Independent Verification Memo: Pump Module Selection, WO-01

Verified energy per common acceptance run (kWh) for all four qualifying modules, with quality and defect values shown; the largest gap (40 kWh, P2 to P3) and both policy gates are annotated.

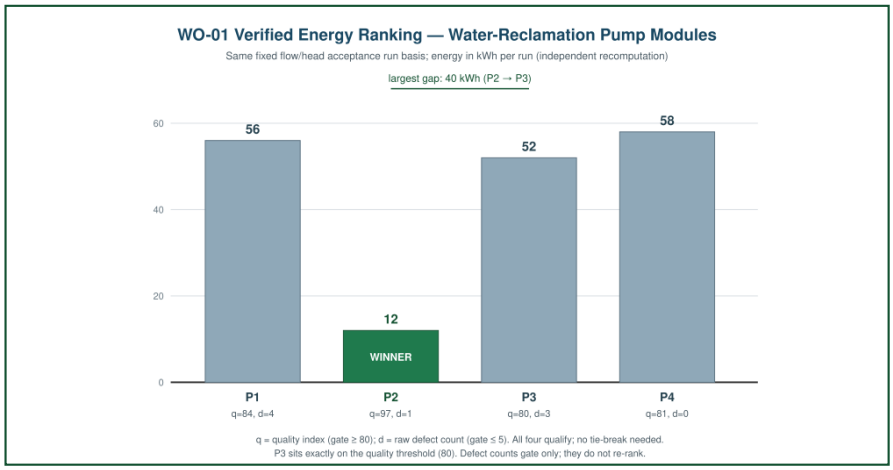
At the common fixed-flow, fixed-head acceptance basis the energies order as P2 12, P3 52, P1 56, P4 58 kWh per run. Gaps from the leader: 40 kWh to P3, 44 to P1, 46 to P4. The three followers cluster within 6 kWh of one another, while P2 is an extreme outlier on the low side. Because all modules were tested on the identical duty, these differences are directly comparable and are not measurement artifacts of differing test conditions. No tie occurs, so the candidate-ID tie-break is never exercised.

I checked the proposal's claims one by one. Its eligibility table, quality values, defect counts, energy values, ranking, gap arithmetic (40/44/46 kWh) and the note that P3 is exactly at the threshold all match the trusted table. Its statement that defect counts gate eligibility but do not re-rank qualifying modules is correct policy reading. One element is a judgment rather than policy: the proposal frames P4 as a 'managed fallback' should P2's defect prove systemic. The policy defines no fallback mechanism, so this is reasonable planning language, not a binding rule, and it does not alter the award. I found no factual errors in A.

Independently verified: P2 is the lowest-energy qualifying module at 12 kWh, 40 kWh below runner-up P3, with the highest quality index (97) and one raw defect, well inside both gates. No tie-break applies. My recomputation from the trusted table confirms the proposal's figures and its client-correct conclusion.
